UNITED STATES PATENT AND TRADEMARK OFFICE

09/739,218

Office Action Summary	Application No. 09/739,218	Applicant(s) KAI ET AL.	
	Examiner Tuan M Nguyen	Art Unit 2828

DETAILED ACTION

FIG.14

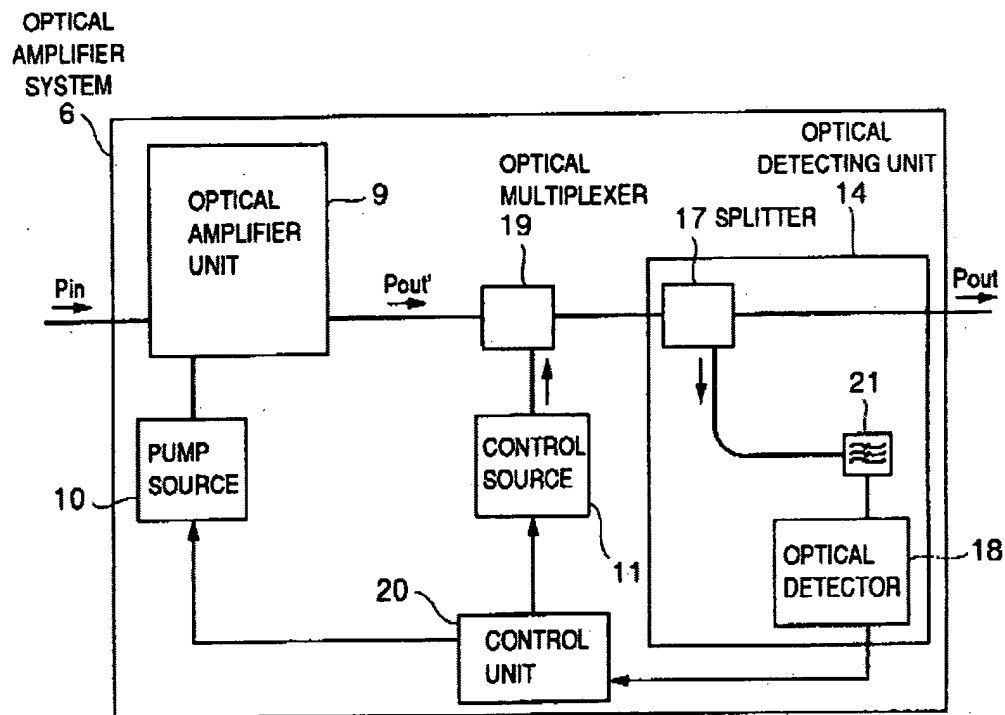
With respect to claims 1 and 14, Kosaka discloses an optical amplifier unit control methods, optical amplifier systems and systems which use the methods and amplifier systems comprises an optical amplifier unit (9), a laser pump source (10), an optical detecting unit (14) including an optical detector (18), a wavelength filter (21), a controlling unit (20), note col. 20 lines 17-34, see fig 14.

With respect to claims 4 and 5, Kosaka discussed about the controlling means (20) see fig 14, Kosaka also discussed about the wavelength oscillation and center wavelength, note col. 1, 2 and 24, see fig 41a and 41b.

With respect to claim 7, Kosaka discloses the optical amplifier system (6) and optical amplifier unit (9), see fig 14. Kosaka also discussed about the optical amplifying means, note cols. 14-16.

With respect to claim 13, Kosaka discussed about the oscillation wavelength and temperature controller, note col. 24, see fig 14.

With respect to claims 11 and 12, Kosaka discussed all about except for the filter is a plurality of filters. However Kosaka shows the optical detecting unit (14) including a filter (21), see fig 14. It would have been obvious to one having ordinary skill in the art at the time the invention was made to have the wavelength filter, since it has been held that discovering an optimum value of a result effect variable involves only routine skill in the art. *In re Boesch*, 617 F.2d 272, 205 USPQ 215 (CCPA 1980).
